Field Safety Notice: ABL90 FLEX / ABL90 FLEX PLUS

ABL90 FLEX (393-090) and ABL90 FLEX PLUS (393-092)

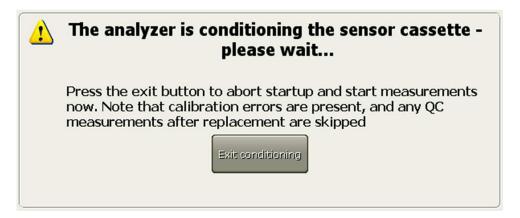
During the Conditioning mode the following is displayed on the screen:

If "Exit conditioning" is pressed to run an urgent sample the analyzer goes to "Ready" without performing three levels of quality control, which are run upon automatic exit. The regular QC schedule, one level every eight hours, will be effective, though.

As a result, no QCs are run during the period from where the conditioning was manually exited to when the first level of the regular QC schedule is run (default every eight hours). The analyzer does not indicate the exit from the Conditioning mode and the patient results are not flagged for QCs not being run.

Avoid exiting manually from the Conditioning mode

• If early exit from the Conditioning mode is required then manually run all three levels of QC upon exit **before** running patient samples.
